Sub: Correction Slip No.143 to the Indian Railways Permanent Way Manual.

INDIAN RAILWAYS PERMANENT WAY MANUAL
CORRECTION SLIP NO.143 DATED 19.04.2018

The existing para 237 and Annexure 8/3, 8/3A & 8/4 of Para No. 807 & 808 of Indian Railways Permanent Way Manual shall be replaced by the following:

ANNEXURE 8/3 - PARA 807 & 808

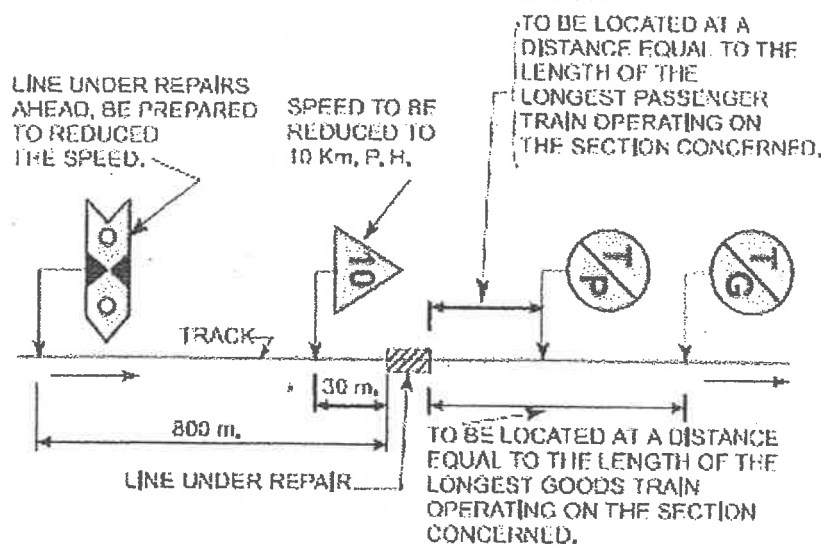
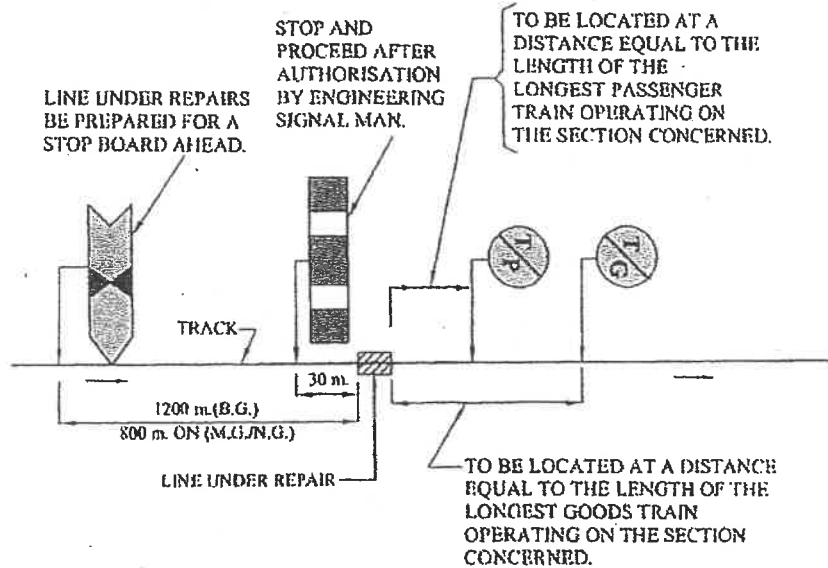
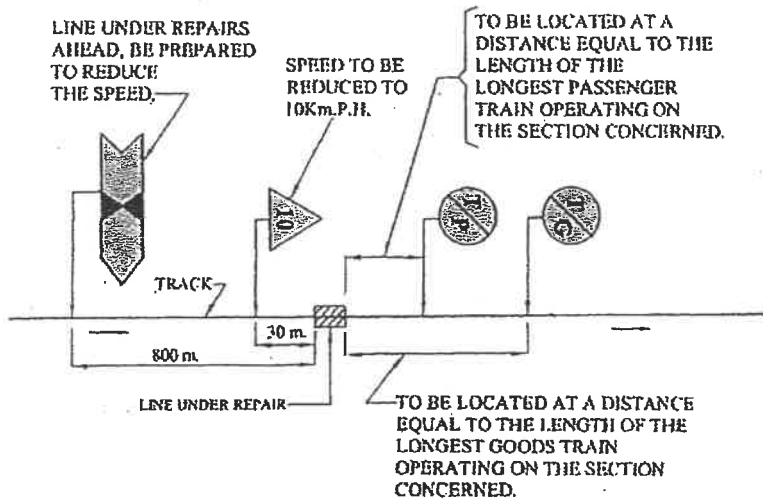
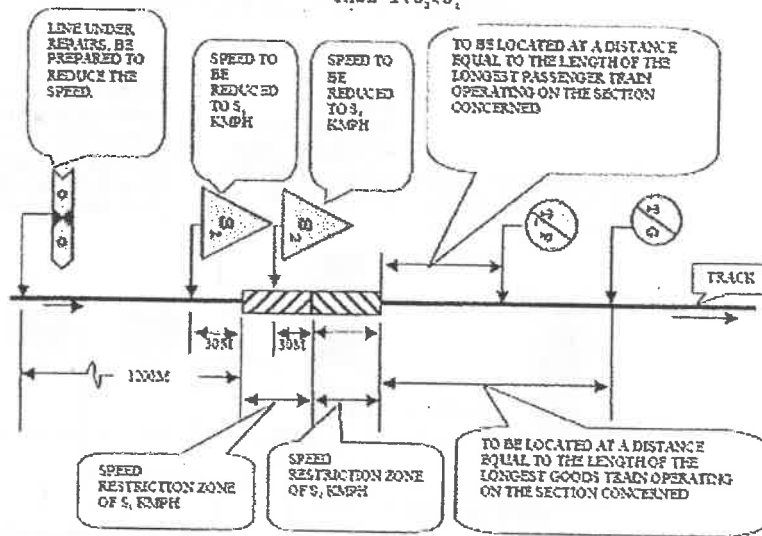
- 2.0 The existing Annexure 8/3, Annexure 8/3A & Annexure 8/4 of Para 807 & 808 at page 210, 211 & 212 of Indian Railway Permanent manual-2004 shall be replaced with the modified Annexure 8/3-Para 807 & 808, Annexure 8/3A-Para 807 & 808 & Annexure 8/4-Para 807 & 808 respectively (Attached).

(II) RETRO REFLECTIVE TYPE BOARDS – TO BE PROVIDED IN NEW CONSTRUCTION AND DURING REPLACEMENT OF EXISTING BOARDS

ANNEXURE 8/3A-PARA 807 & 808

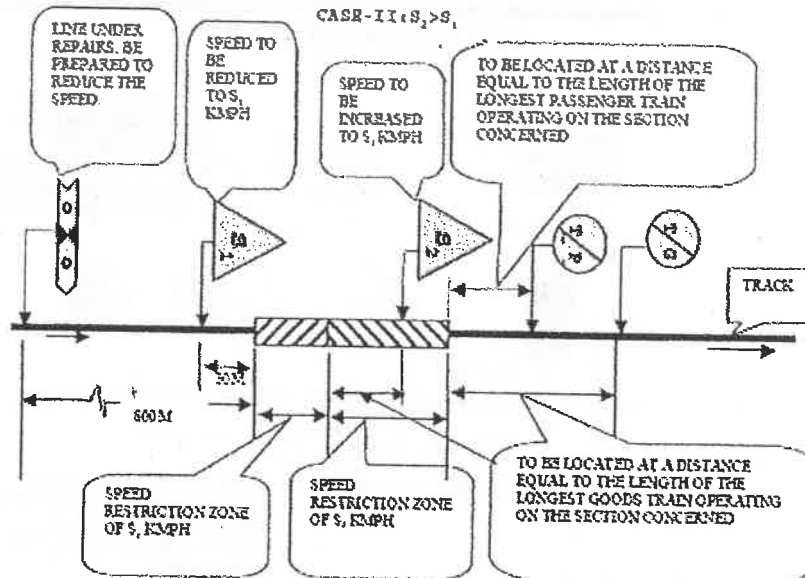
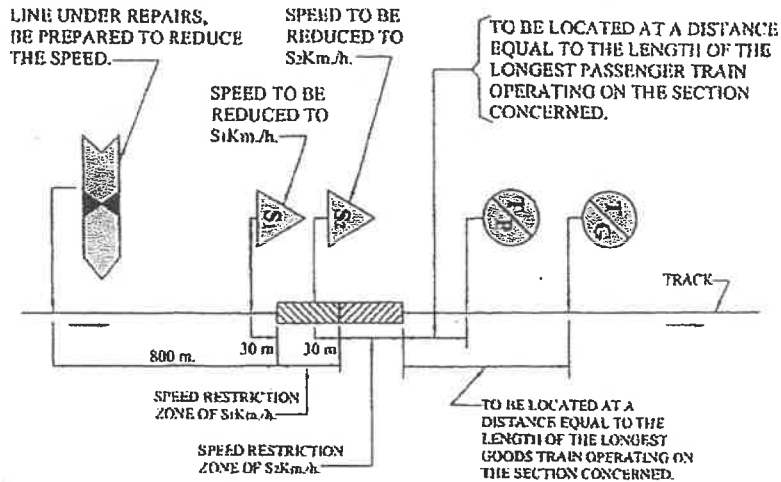
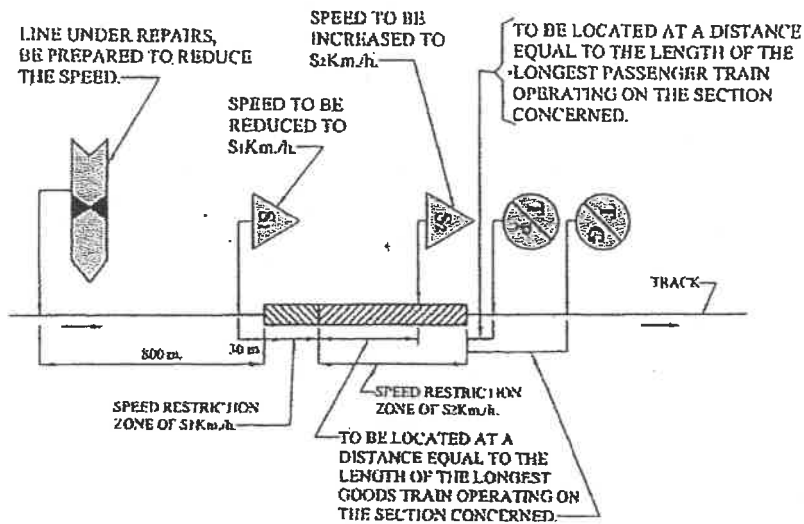
(II) RETRO REFLECTIVE TYPE BOARDS – TO BE PROVIDED IN NEW CONSTRUCTION AND DURING REPLACEMENT OF EXISTING BOARDS

NOTE : MIN LENGTH OF SPEED RESTRICTION ZONE OF S_1 Km/h SHOULD BE 200m. OTHERWISE SPEED INDICATOR BOARD S_2 SHALL BE PROVIDED AT THE PLACE OF S_1

ENGINEERING INDICATORS
FOR TEMPORARY RESTRICTIONS

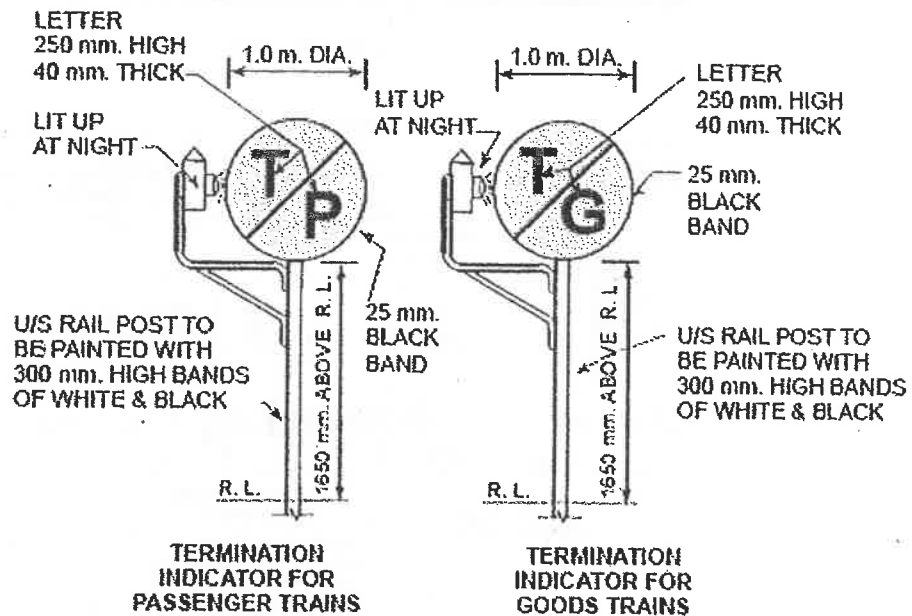
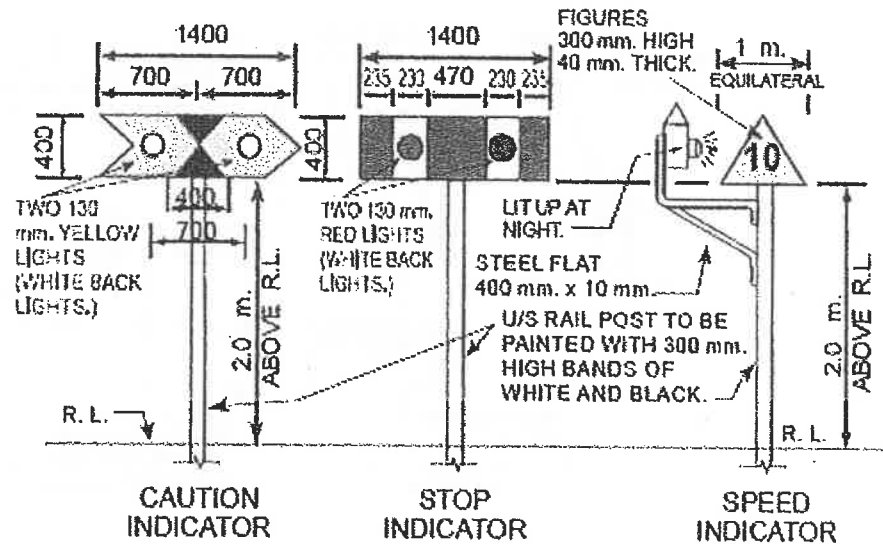
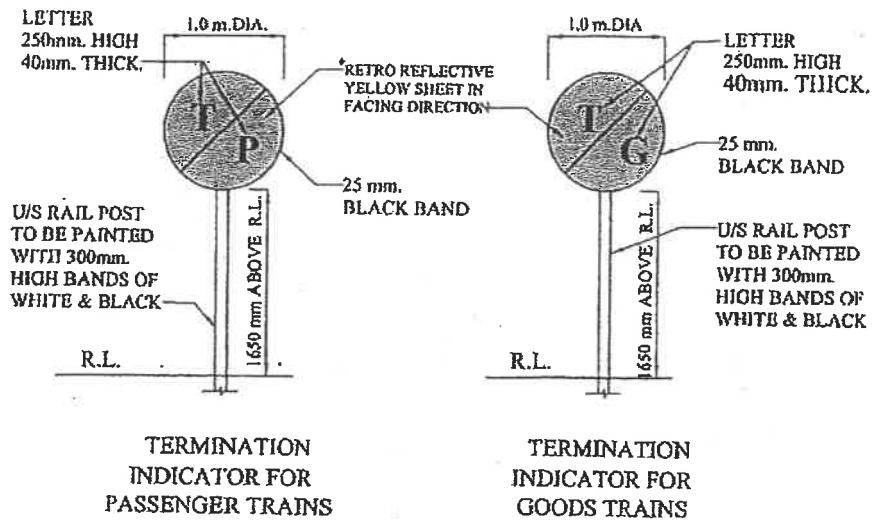
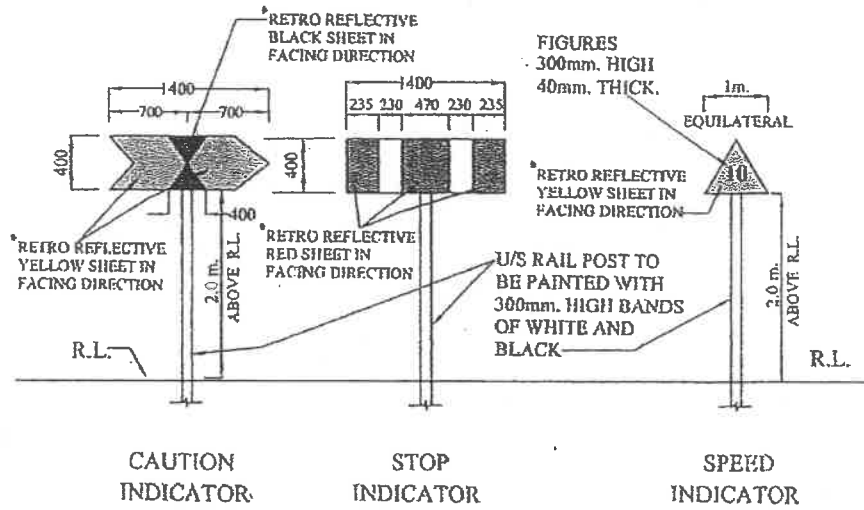
(II) RETRO REFLECTIVE TYPE BOARDS - TO BE PROVIDED IN NEW CONSTRUCTION AND DURING REPLACEMENT OF EXISTING BOARDS

NOTE: All engineering indicators should be of retro reflective type as per R.D.S.O. Provisional Specification for Retro reflective Indicators, May 2011
